ENHANCING LAST MILE CONNECTIVITY

a safety analysis of the Barakhamba Road Metro Station

This Report has been prepared as part of the Project being undertaken with NDMC to Enhance the Last Mile Connectivity along the metro stations within it's jurisdiction. The safety audits were conducted by Smt. Nutan, architect from NDMC along with Safetipin team.

Lighting Rating

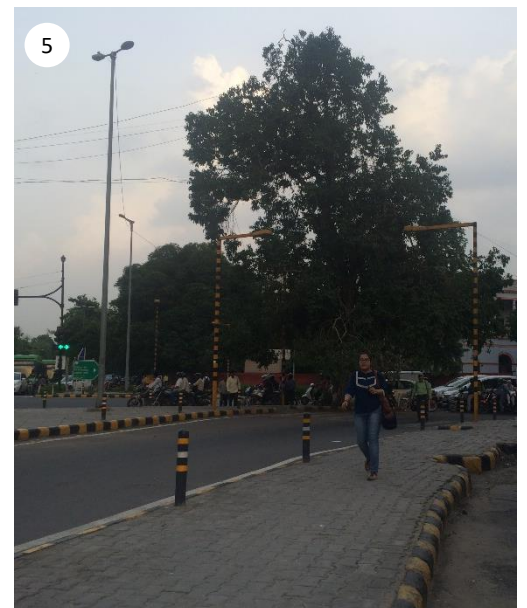
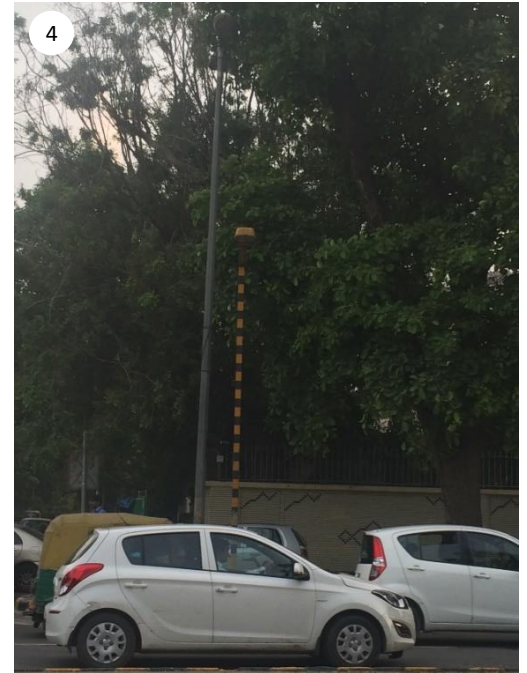
A few light fixtures were found to be un-operational. Regular maintenance checks are needed to ensure that all streetlights are operational at all times. Also, the lights need to be well spaced to ensure the entire area is well lit.

A few street poles do not have any light fixture installed on them. Light fixtures should be fixed and energized to sure illumination. Also tree leaves need to be pruned.

Some streetlights are covered by tree leaves resulting in dimmed illumination. Regular pruning of tree leaves is essential to prevent this.

At few points , multiple streetlights have been located in close proximity. While installing new lights care should be taken to evenly space them such that the entire road stretch is uniformly illuminated. Currently while few spots are very brightly lit, other are not well lit. This also causes glare and should be avoided. Such poles should be re-located at a certain distance.

Walkpath Rating

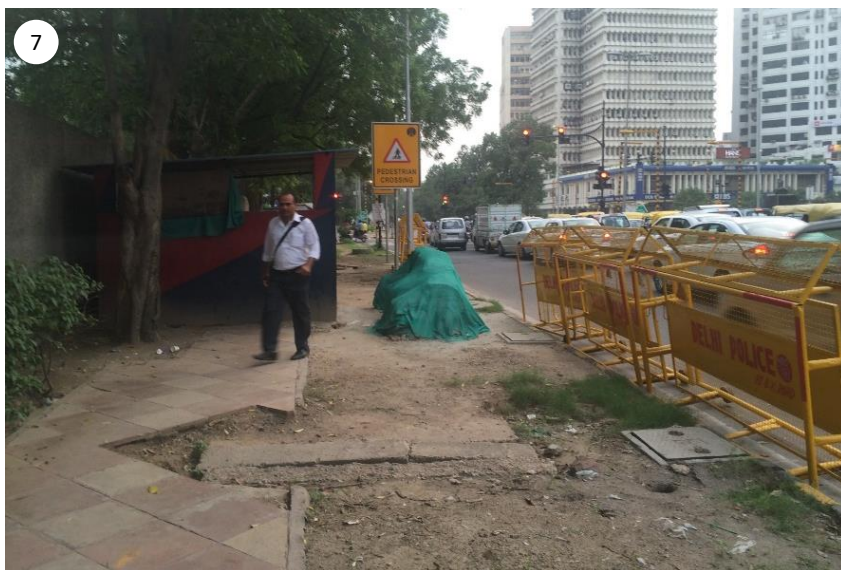
The tactile paving on the bus stop ends abruptly at the kerb. The kerb height is more than one foot which further makes it risky for the visually impaired. Tactile paving needs to be provided along the entire length of footpath and connected with the paving at the bus stops and metro stations.

The ramp to the Public Convenience does not have any tactile paving. Though it has a rough surface for easier movement of wheelchair, tactile paving too needs to be incorporated.

Bollards have been located randomly such that they not only prevent wheelchair movement but also obstruct pedestrian movement. Bollards should be spaced such that wheelchair can pass. A ramped edge also needs to be created.

Ramps have been provided for egress/ingress but these are too steep and without proper turning radius. Also, as seen here in pic4, bollards have been located blocking the ramp. These need to be removed and a proper ramp be created. In pics 5&6, the ramp ends into the boundary wall and there is no space for a wheelchair. Even for pedestrians it is difficult to move. Also the ramp should be clear of the footpath such that pedestrian movement is not disrupted.

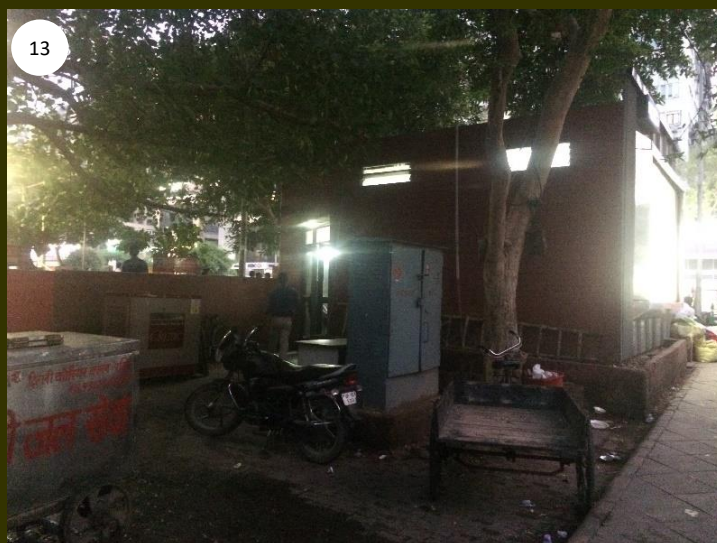
The footpath is not provided outside the entry to Hans Hotel. In order to cater to both pedestrians and the vehicles entering/exiting from the hotel, the footpath should be made continuous with ramped egress/ingress i.e. designed as a table top. Private driveways should not be allowed to encroach upon the public right-of-way.

The zebra crossings too need to be continuous throughout the entire width of the road. The median should be broken at the zebra crossings.

The Public Convenience facilities need to have proper access to them. As seen in pic13, the footpath is not connecting to the Toilet and there are many obstructions in between. The space abutting the Toilet should be cleared and properly paved including provision of tactile paving.

Visibility Rating

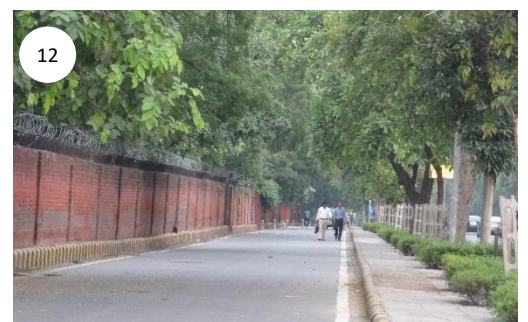
At certain locations like junctions and turnings and along public functions, there is vacant space which can be developed as a proper public space with street furniture and lighting. A small kiosk can also be incorporated. This would result in various small activity hubs scattered throughout the area making it more active and safe.

The boundary wall along Parsvanath building is low in height and has a planter. It allows for a visual connection hence enhancing visibility. Hawkers are present along it and people use the boundary wall as a seater. This should be adopted along the remaining area as well.

Seen above the boundary wall is not very high and allows some connection. It even has light fittings which add to the illumination. Street furniture can be incorporated in between the planters along with space for small kiosks. Alternately the wall height can be further reduced.

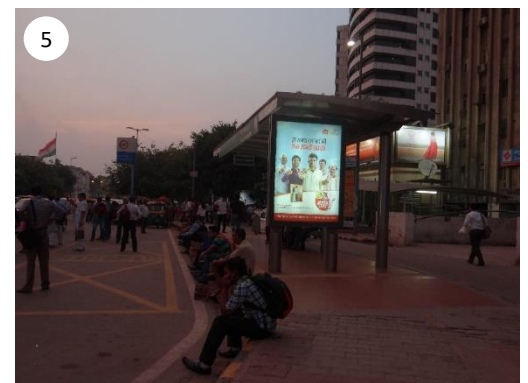
Shown here is the bus stop in front of Kanchenjunga building. It is located along the service lane. Proper turning radius hasn't been provided for the movement of buses. Furthermore, cars are parked in front of the shelter blocking bus movement completely. As a result while a few people wait in the shelter most people prefer to stand on the footpath along the main road. Proper turning radius should be incorporated at the junction and any obstruction should be prohibited.

A Cycle Sharing System has been started along this metro station. However, the number of Cycle Stations is limited. These not to be provided at regular distances in the entire area for people to be able to avail this facility.

Seen above in pics 4 & 5 are people sitting on the footpath in the absence of adequate provision of street furniture. In pic 4, there is no bus shelter. A bus shelter needs to be provided clear of the footpath with adequate seating facility. In pic5, the bus shelter has been provided but the seating falls short of the footfall witnessed. Additional bus shelter should be provided.
